Office Action Summary

10/707,601

HEBERT ET AL.

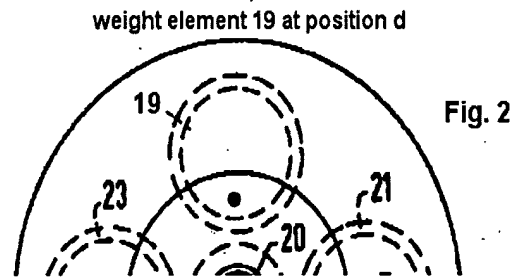
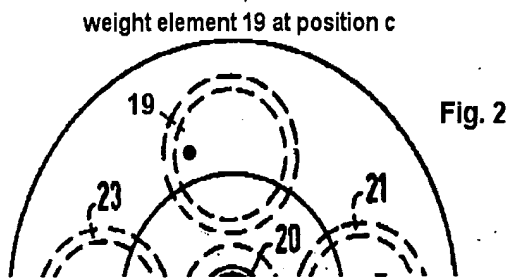
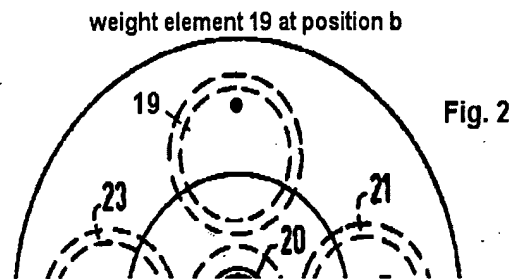
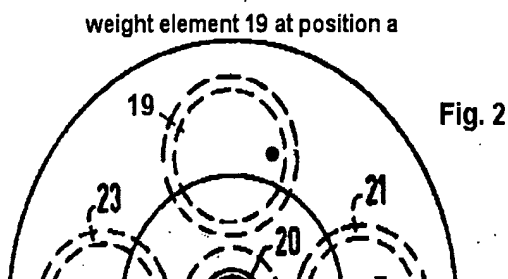
Furthermore, Schleinkofer reads on at least claims 1 and 13 as recited. The features (fig. 2, features occupied by #12 or 17-19) of Schleinkofer read on circumferential features, since the cross area of these features are in the shape of a circle. In addition, the weight element (fig. 2, #12 or 17-19) of Schleinkofer reads on "at least one weight element adapted to be securable in any of a plurality of positions within one of said circumferential features". In other words, the

weight element (fig. 2, #12 or 17-19) is capable of being secured in any of a plurality of positions within one of said circumferential features. See figure 2 as modified below with the reference point on the weight element signifying the plurality of positions that the weight element is capable of being secured at within the circumferential feature.
